FIELD SERVICE BULLETIN

FSB Number:	BJCCFSB2006-109
Author:	Feng Joanna
Date:	Mar 16, 2006
Total No. of Pages:	3
Subject:	V3i Can't Enter Camera Mode_Connector Pin Deformed
Model Affected:	V3i
Level of Repair:	2

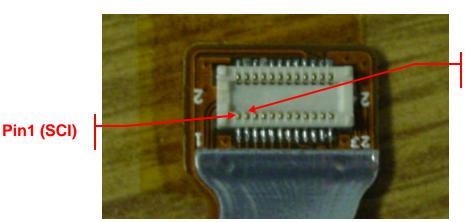
2) Phone displays "busy. Try again later" when enter video camera mode.

To Enter Video Camera and pressing the select key

Display "Busy. Try Again Later."

When servicing any V3i customer return with described issue, replace the camera module (Part No. 8489891Y01). Otherwise, please follow normal troubleshooting procedure on this unit or send it to Motorola for further analysis.
